VARTRY WATER TREATMENT WORKS UPGRADE

AN BORD PLEANALA REF. 27.247745

REPORT ON HYDROLOGICAL ISSUES

FIG. 2 : 21 MEASUREMENTS OF FLOW IN THE VARTRY RIVER (13 Jan to 2 June 2017) AT ANNAGOLEN BRIDGE BY IRISH WATER (CAPITAL WATER) COMPARED TO THE FLOWS LIKELY TO HAVE OCCURRED UNDER THE PROPOSED NEW REGIME (graph based on evidence presented at oral hearing)

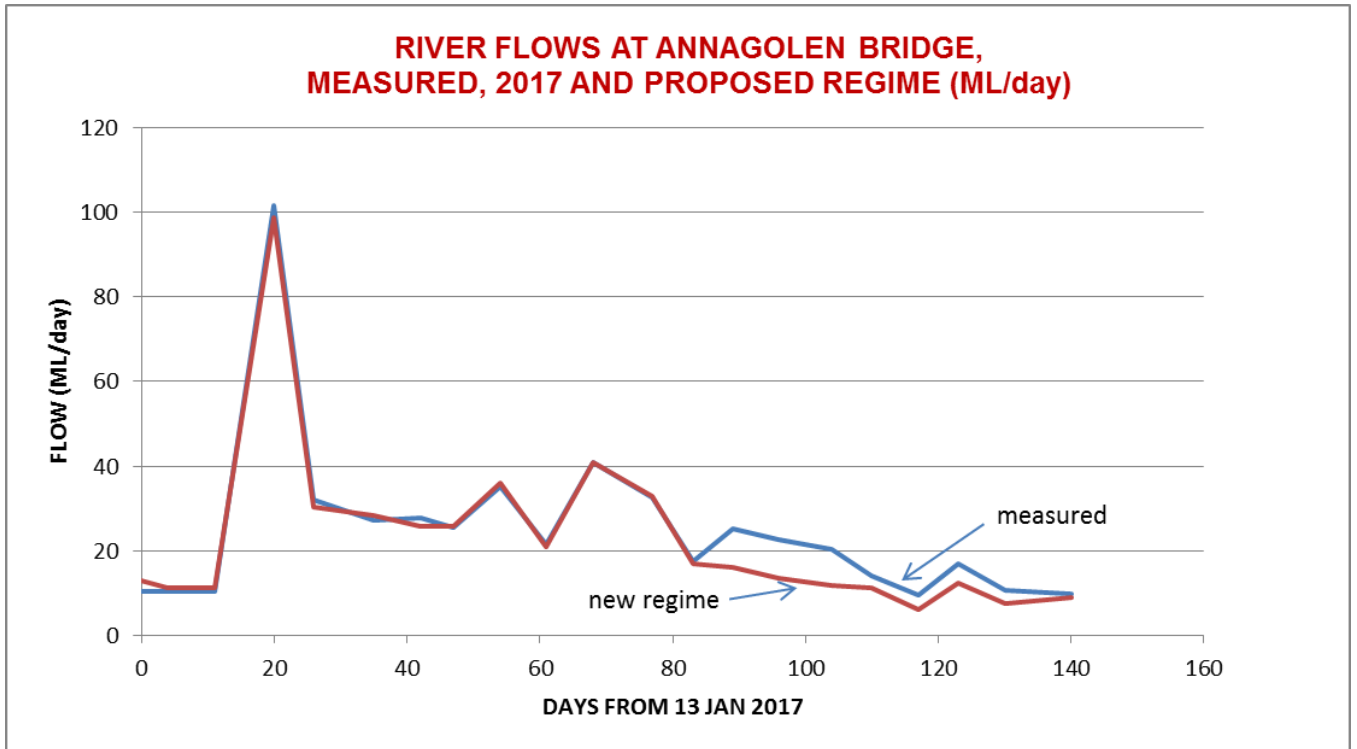
The current, increased leakage from the WTP site of 10.5 MLD (mean) which has lasted for approximately 10 years is perceived by the appellants to have significantly changed the eco-flow regime of the river downstream. The hard evidence for this is scarce, given the lack of hydrological data below the WTP site over this period. The only available data is from the sets of flow gaugings made on the Vartry at 6 separate points on each of 21 days between 13th January and 2nd June 2017. Flow measurements were made upstream and downstream of the WTP discharge (so that the net release from the WTP could be determined), at Annagolen Bridge, Nun's Cross Bridge, Ashford and Newrath Bridge (Figure 1). From these data, the mean discharge to the river from the WTP in 2017 was 7.0 MLD during this period. Based on data given in evidence by IW, a plot of these data is drawn in Figure 2 to show the difference with the flows that would have occurred under the proposed regime at Annagolen Bridge.

The lowest recorded flows (10th May 2017) indicate that the WTP discharge forms 89% of the flow at Annagolen Bridge (9.6 MLD) which would increase to 91% under the new regime (5.5MLD). On the same day, downstream, the proportion of the flow at Newrath embodied 28% from the WTP which would become 18.5% under the change. At Annagolen Bridge, this reduction in flow amounts to a change in water level of approximately 50mm, (based on the rating given by Capital Water) whereas at Newrath it amounts to a change of only 6mm.
